Illinois Department of Transportation

SUBJECT: MidAmerica St. Louis Airport
Mascoutah, Illinois
St. Clair County
Illinois Project Number: BLV-5101
AIP Project Number: 3-17-0146-TBD
Contract No. SC071
Item No. 12A, June 16, 2023 Letting
Addendum A

NOTICE TO PROSPECTIVE BIDDERS

TERMINAL APRON EXPANSION -
PROJECT 1

GC102
SHEET 11 OF 60

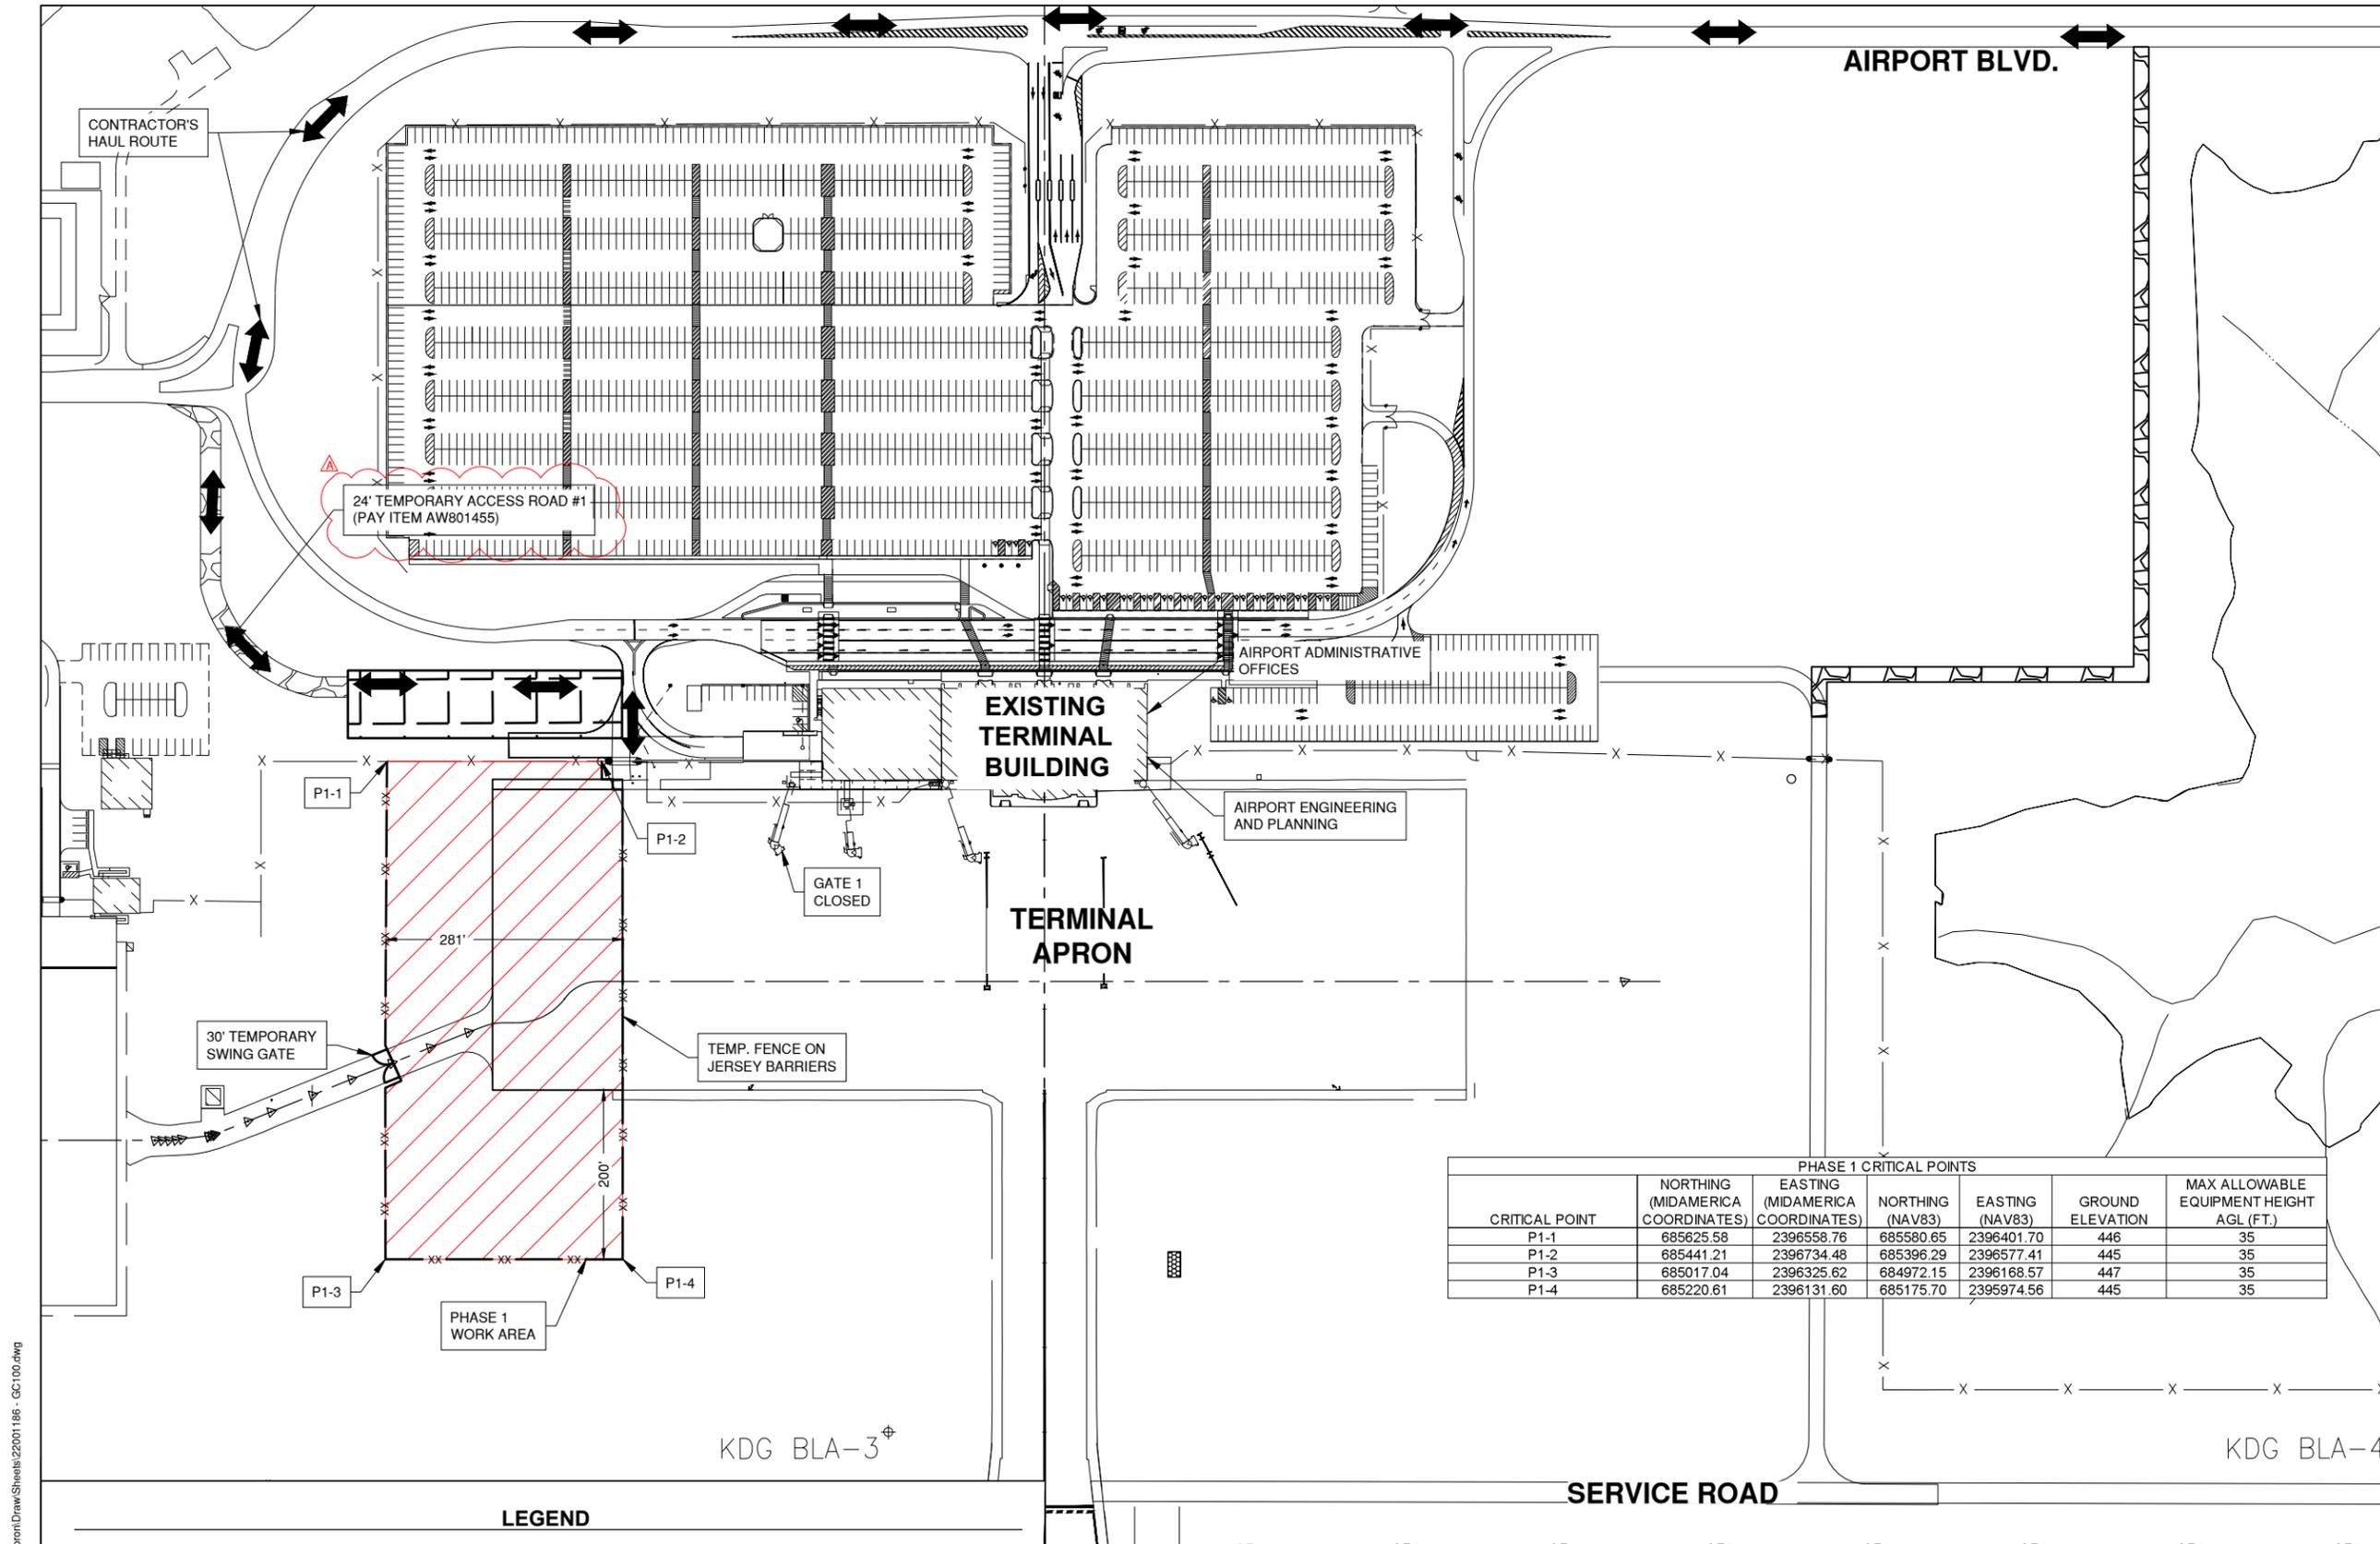
- Sheet GI102
 - Updated to add pay items AW801455 and AW801958.
- Sheet GI103
 - Updated to add pay items AW801455 and AW801958.
- Sheet GC101
 - Updated to show access roads are now pay items AW801455 and AW801958.
- Sheet GC102
 - Updated to show access roads are now pay items AW801455 and AW801958.
- Sheet GC103
 - Updated to show access roads are now pay items AW801455 and AW801958.
- Sheet CI101
 - Updated grades and profile for the service road.
- Sheet CP801
 - Updated staking elevations.
- Sheet CG101
 - Updated contours and structure rim elevations.
- Sheet CG301
 - Updated profile elevations
- Sheet CG302
 - Updated profile elevations
- Sheet CG303
 - Updated profile elevations
- Sheet CG501
 - Add sheet to plan set
- Sheet CG502
 - Add updated plan sheet to plan set
- Sheet CG506
 - Revise call offs on Detail "Part Section A-A"
- Sheet CG706-710
 - Updated cross sections

8. HAUL ROUTES SHALL BE PAID FOR AS PAY ITEMS AW801455 AND AW801958.

CG303
 SHEET 32 OF 60

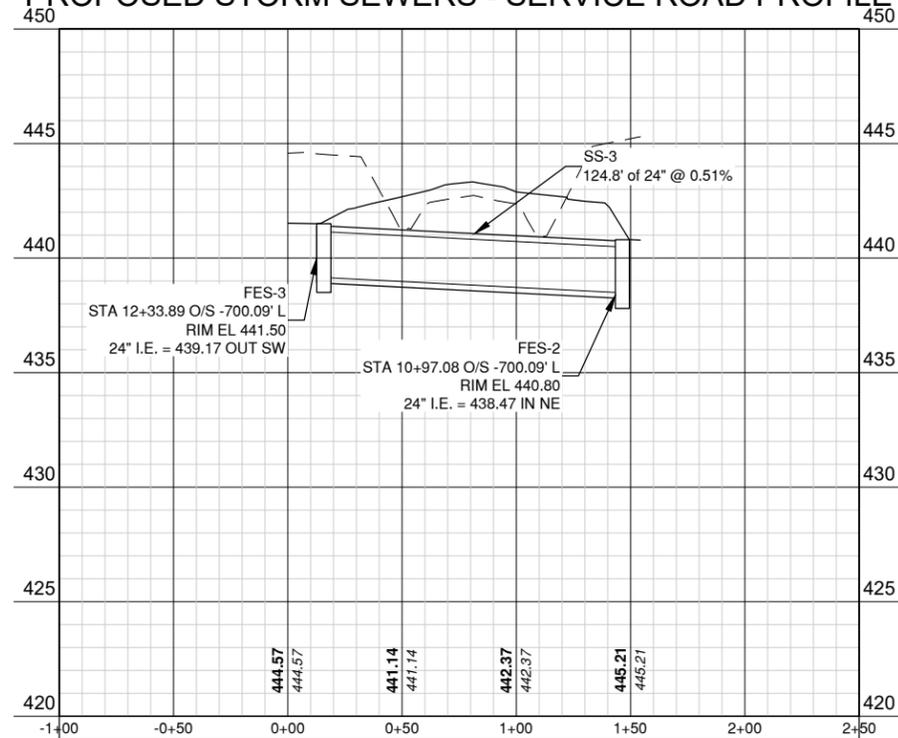
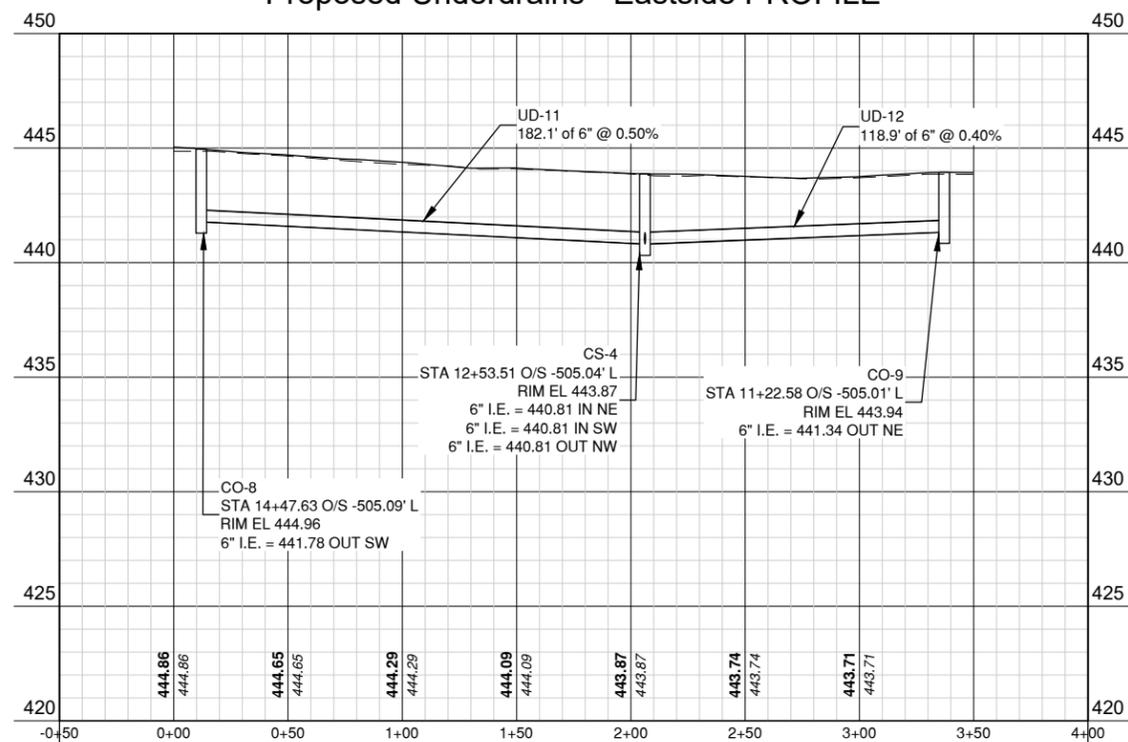
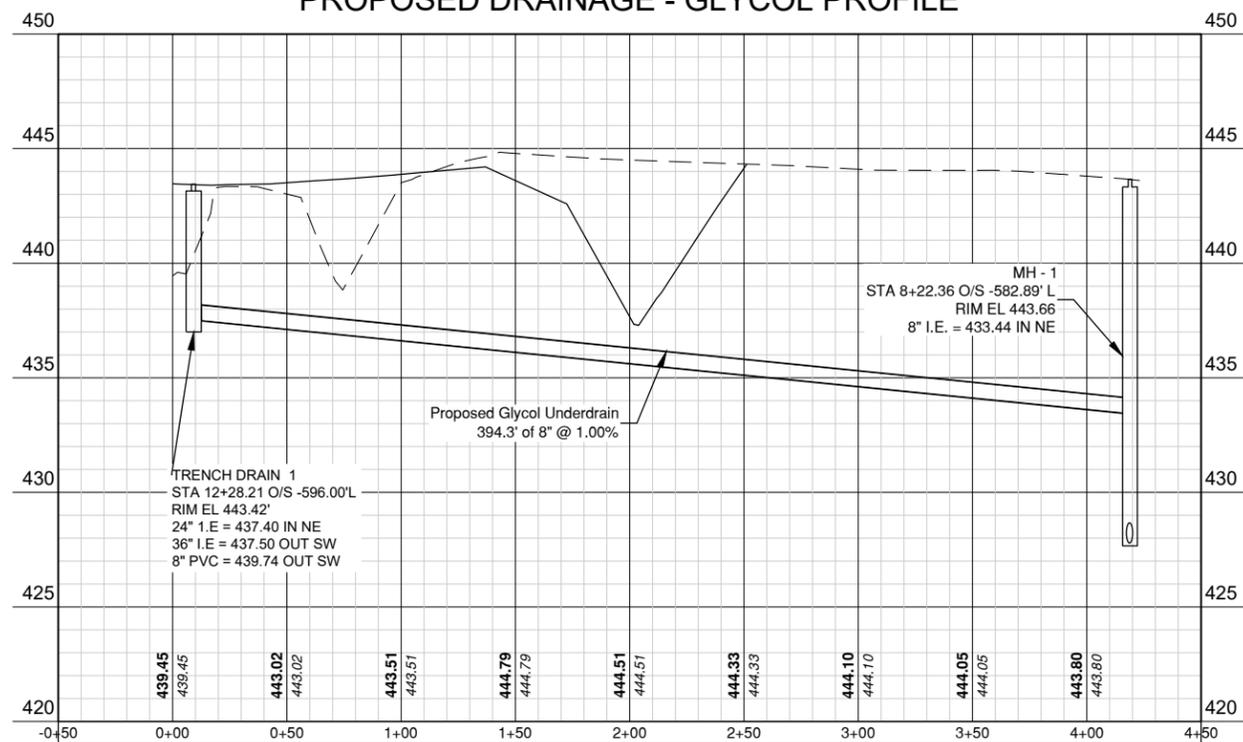
9. Update profiles on Plan Sheet CG301
10. Update profiles on Plan Sheet CG302
11. Update profiles on Plan Sheet CG303
12. Add CG501 to plan set
13. Renumber Plan Sheet CG502

CG706
SHEET 56 OF 60

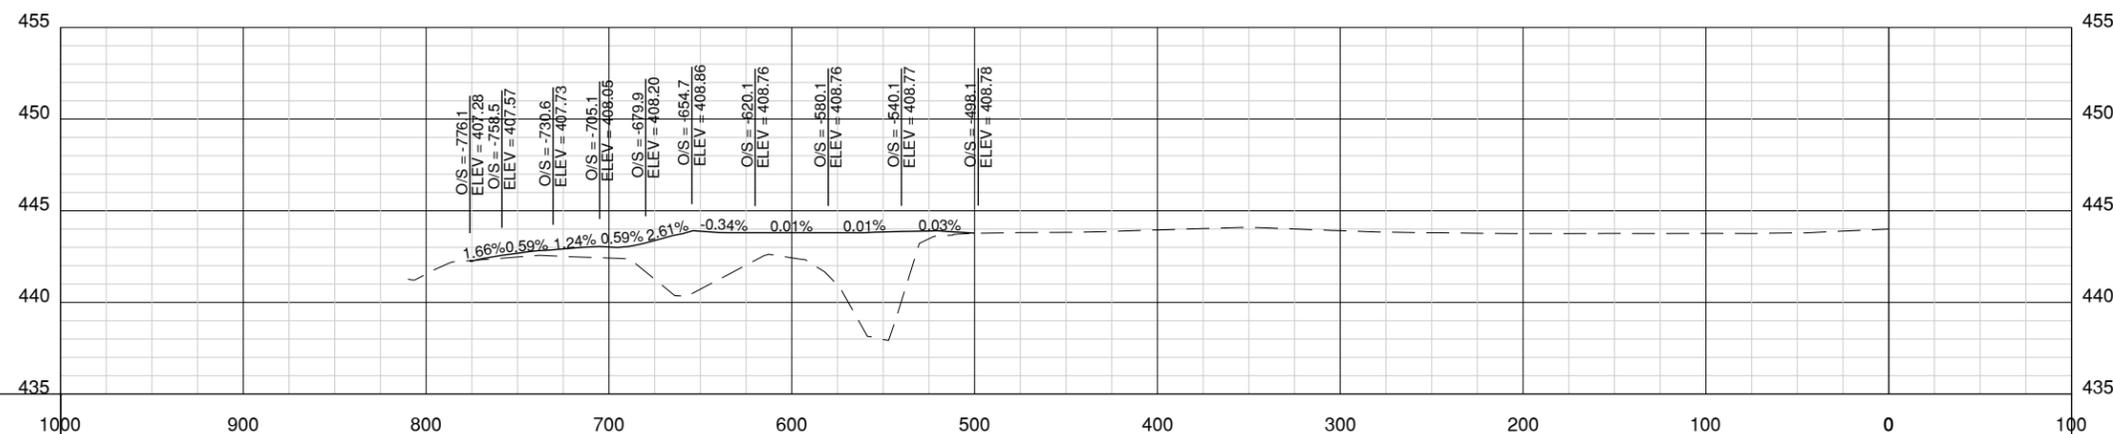
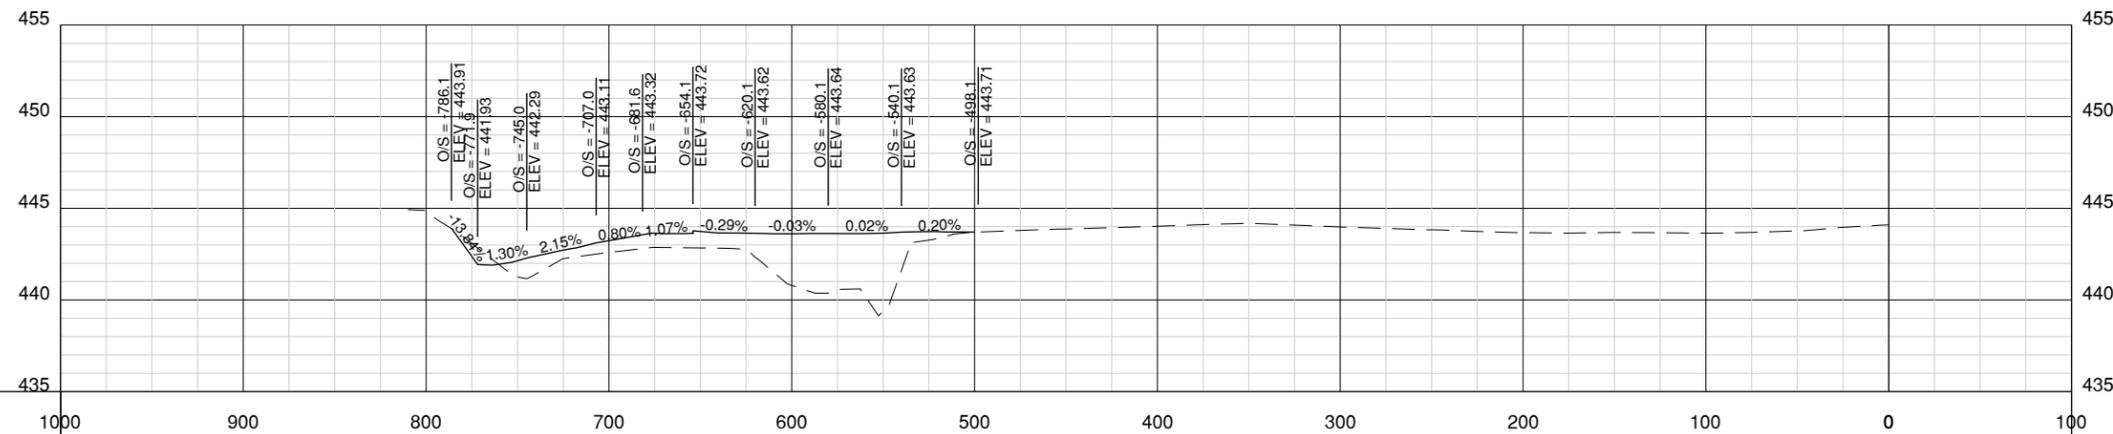
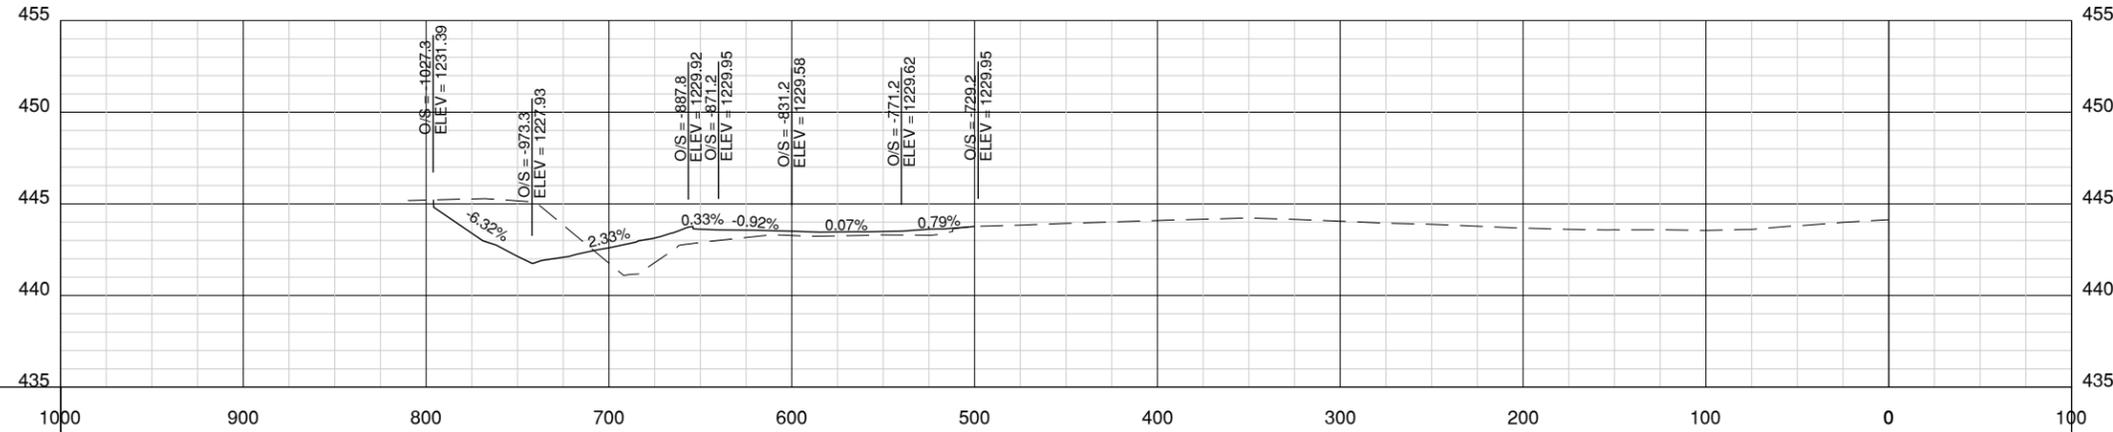
14. Clarify notes on Plan Sheet CG506
15. Update cross sections on Plan Sheets CG706-710
16. Clarify Item SP-3 Sanitary Sewer Installation, Section 3-1.4 Project Conditions
